Amendments to the Drawings

Annotated Marked-up Drawings

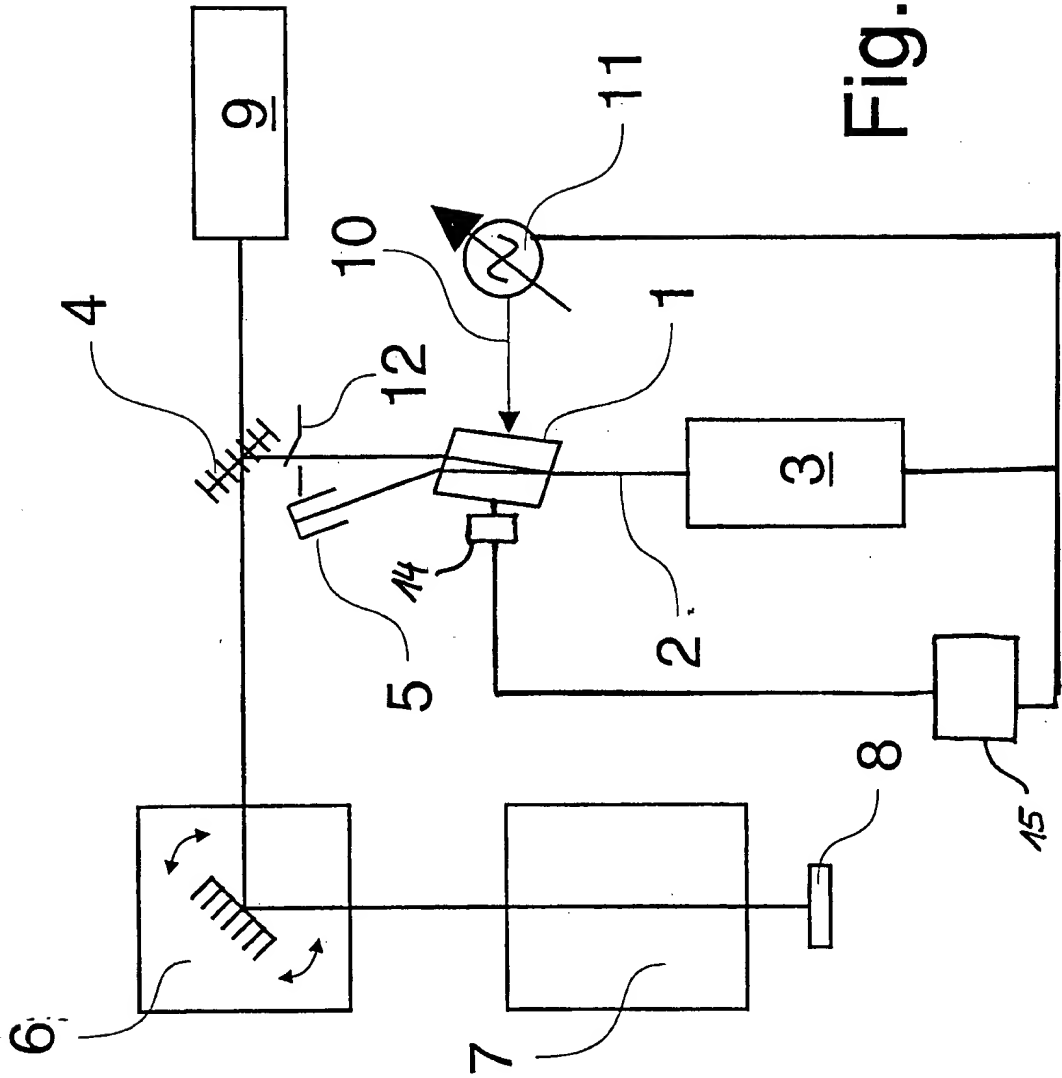
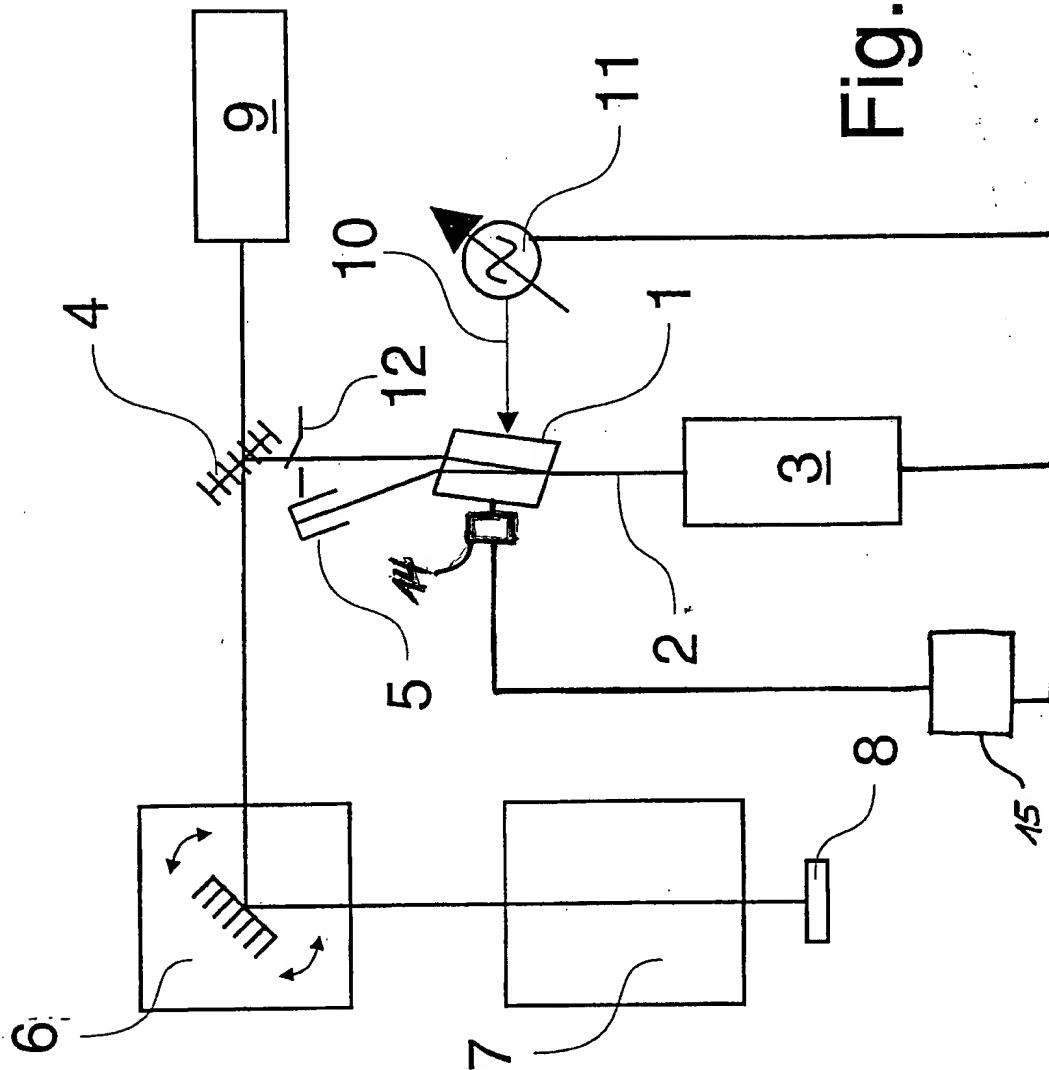
Applicant has amended the drawings to illustrate optional temperature sensor 14 proximate the optically active element. Attached herewith is a clean copy of the proposed amended drawing as well as a marked up version to illustrate the changes (shown in red).
